RE: ZBA2026-080, 374 Thornton Street, B-1

Zoning Relief Required for Subdivision

ZONING REVIEW

SUBDIVISION PLAN FOR
JONATHAN & KRYSTAL VENTURINI
TAX MAP 389 LOT 48
374 THORNTON STREET
MANCHESTER, NEW HAMPSHIRE

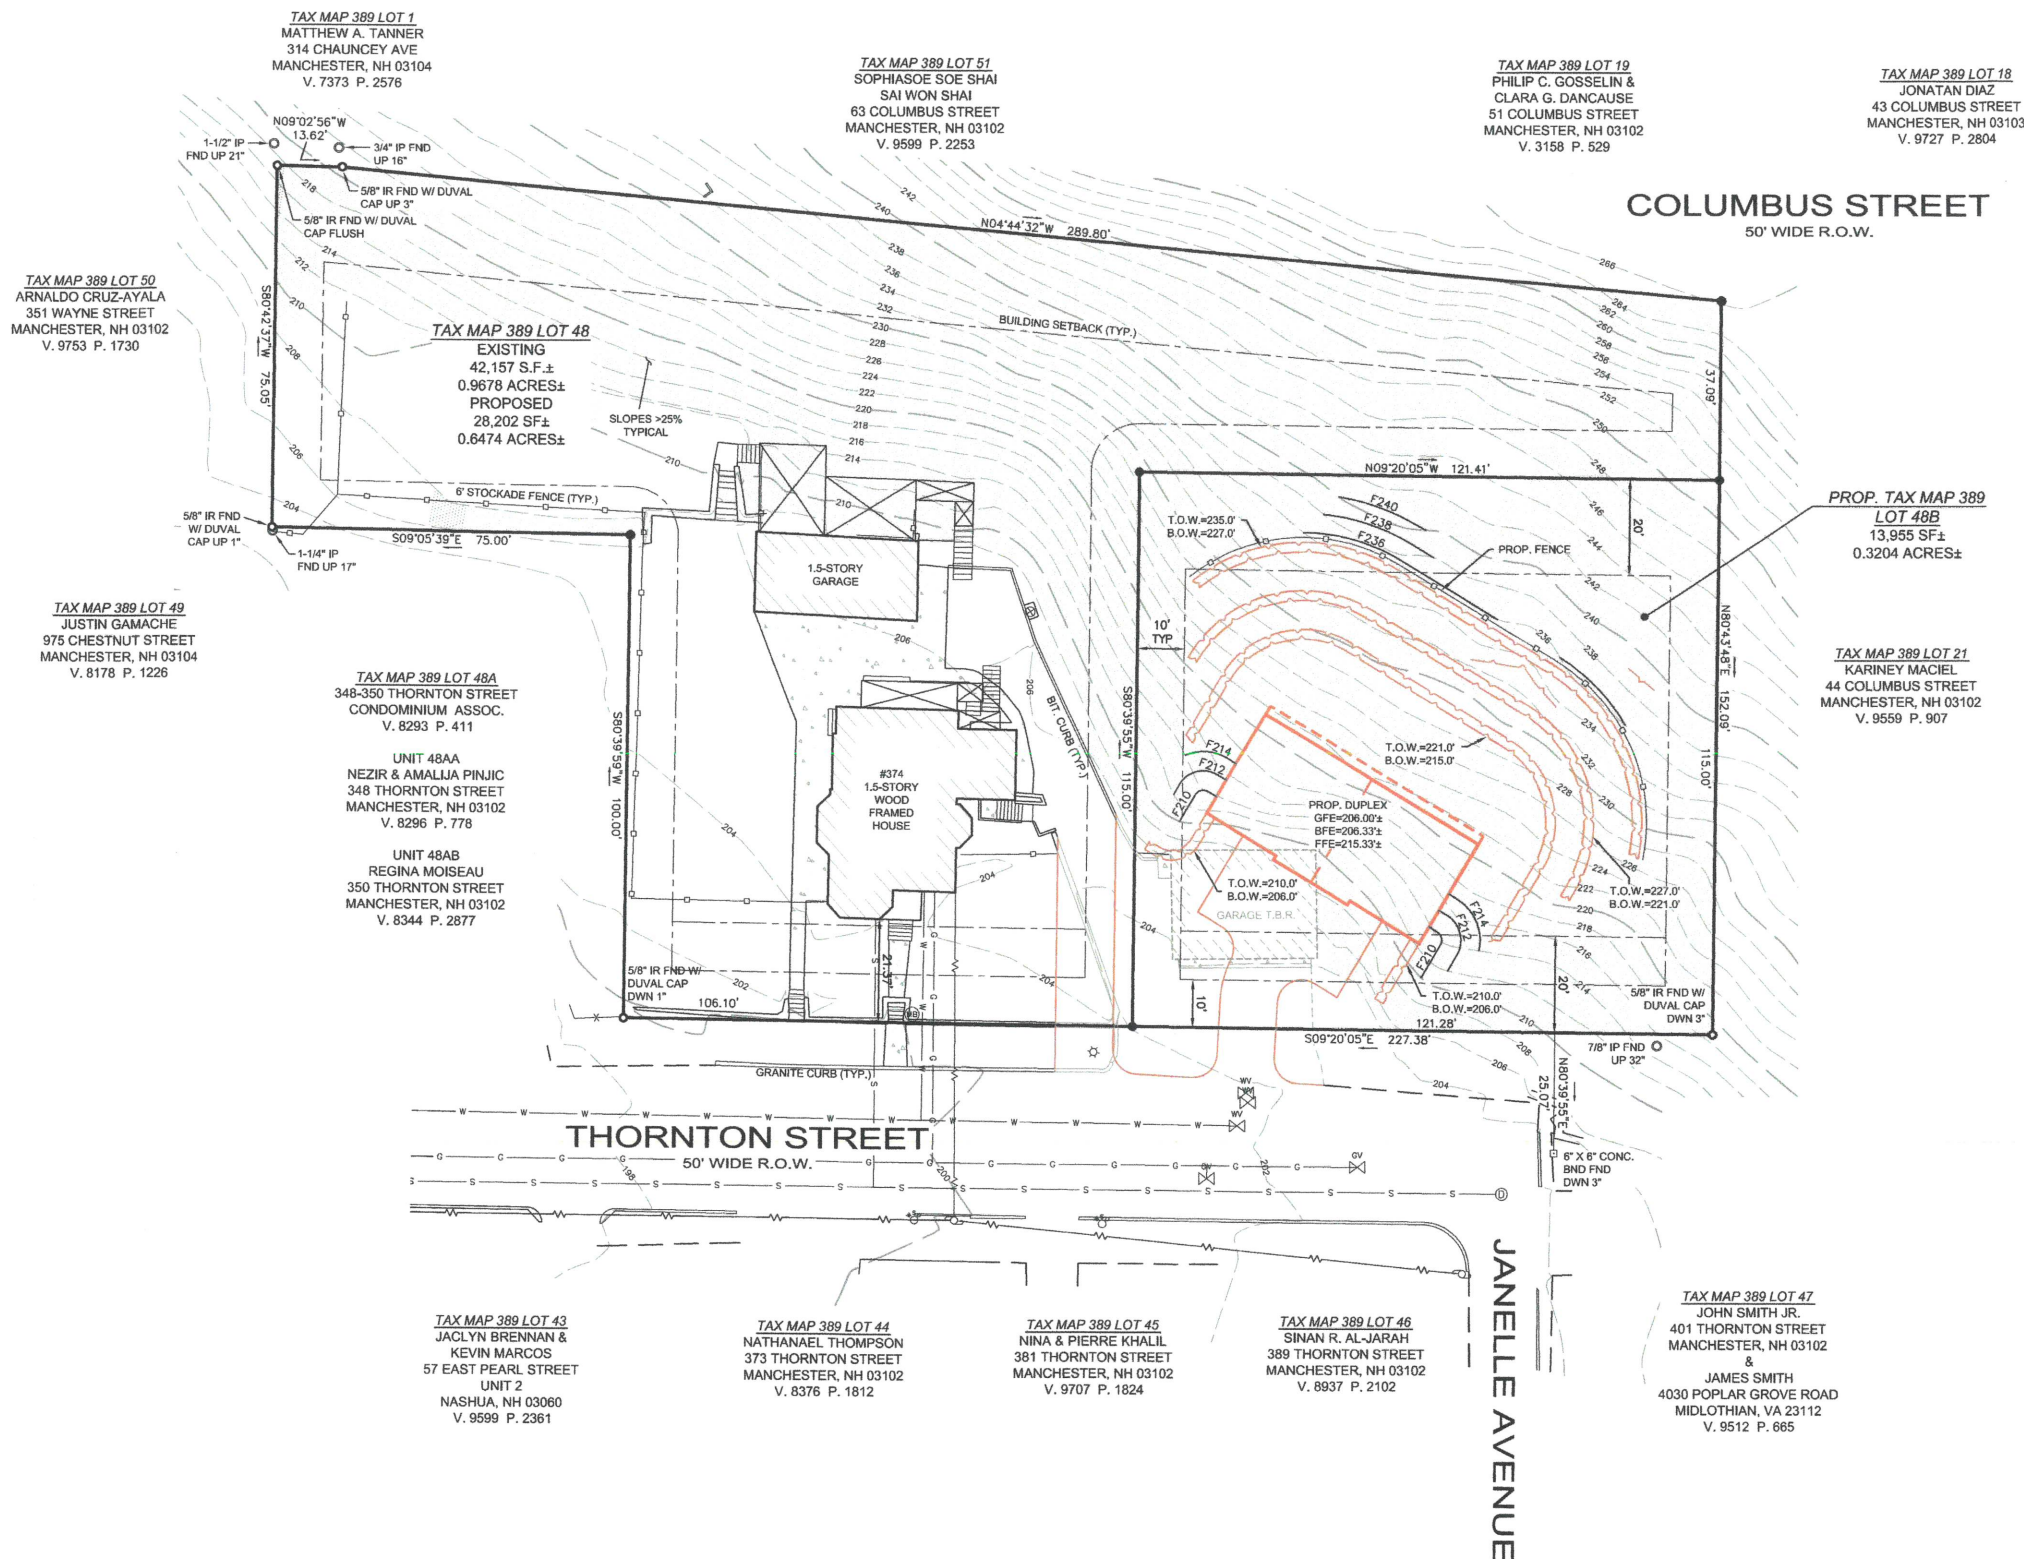
Additional Information: Driveway layout does not provide adequate entry into garages. Any additional pavement will exceed the 25% limit allowed.
